OFFICIAL COORDINATION REQUEST FOR NON-ROUTINE OPERATIONS AND MAINTENANCE

COORDINATION TITLE- 16BON49 summer spill change

COORDINATION DATE- 29 June 2016

PROJECT- Bonneville Lock and Dam

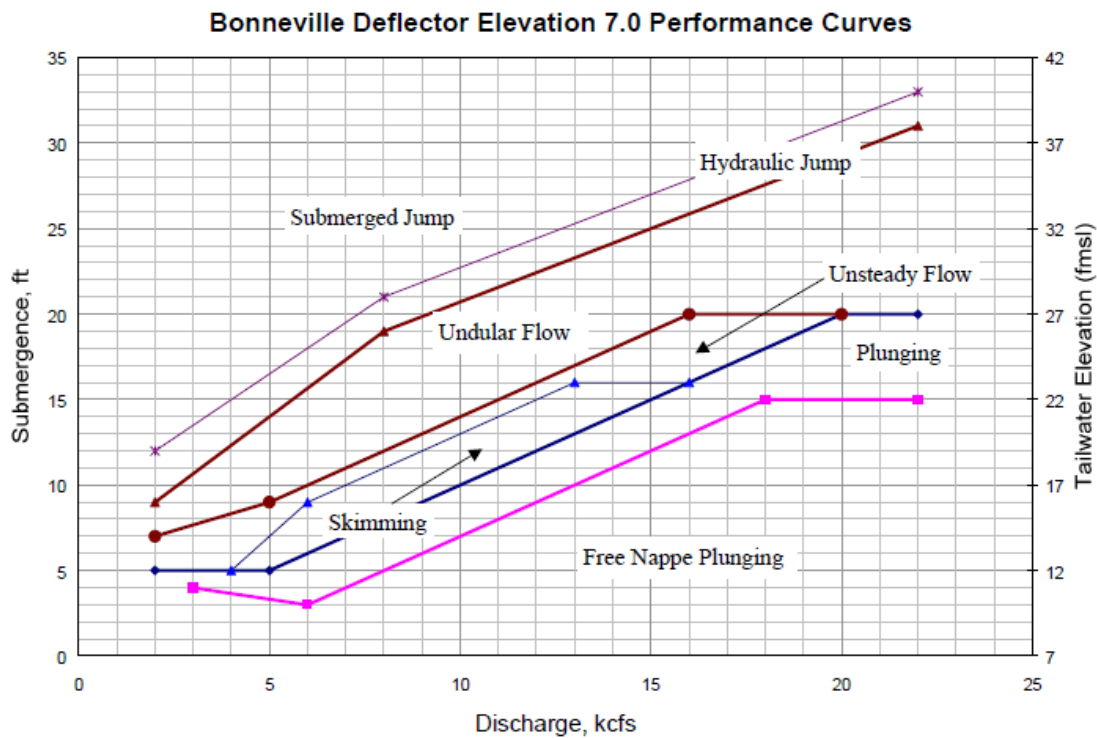
Description of the problem - Erosion holes have been observed in the previously repaired area of the B-Branch riprap. These holes were not observed during the May spillway inspection. Due to the water movement in the eroded areas, there are concerns that the undercutting may extend further beneath the ladder structure. Please see the photos of the erosion areas below.

An investigation as to the cause of the erosion has just begun but there is too much energy being dissipated at the erosion locations. The attached diagram is from the Bonneville Deflector DM (2001). The diagram shows that the flow conditions off of the 7 foot deflector are unsteady (turbulent) for the conditions that have existed much of the past month (17 foot tailwater and about 6600 cfs through Bay 18). Tailwater is expected to drop as we move into July and August; the lower tailwater should help with the unsteady flow. Any change in discharge through Bay 18 also causes an increase in turbulence (energy dissipation). Using a constant spill operation eliminates the additional turbulence associated with gate changes.

In order to minimize the current rate of erosion, the Corps plans to modify the current summer spill operation (alternate every two days between 85 kcfs day/121 kcfs night and 95 kcfs 24 hours per day) to a constant 95 kcfs 24 hours per day effective 8 July through 31 August. Changing to a constant spill operation of 95 kcfs 24 hours per day is needed for the following reasons:
